Special Bulletin

SP16-303B

WHEELCHAIR LIFT CABLE WEAR

Prevost vehicles

Figure 1

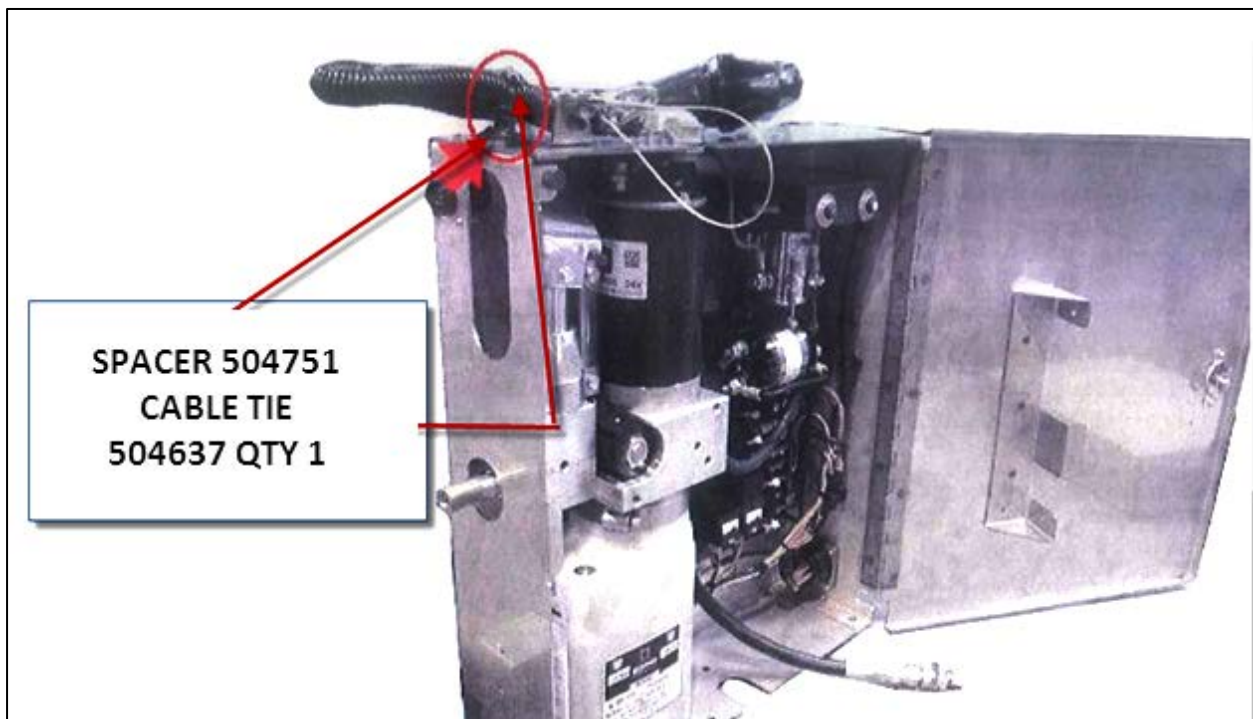
On the vehicles affected by this bulletin, reposition the harness out of the path of an unlocked electrical box door.

- 1) On the WCL control box of the WCL unit:
- 2) Add electric tape 680319 on the cable sheath to secure the electrical wires inside.
- 3) Add a rotary spacer 504751 on the cable over the electric tape.
- 4) Secure with cable tie 504637 qty 1
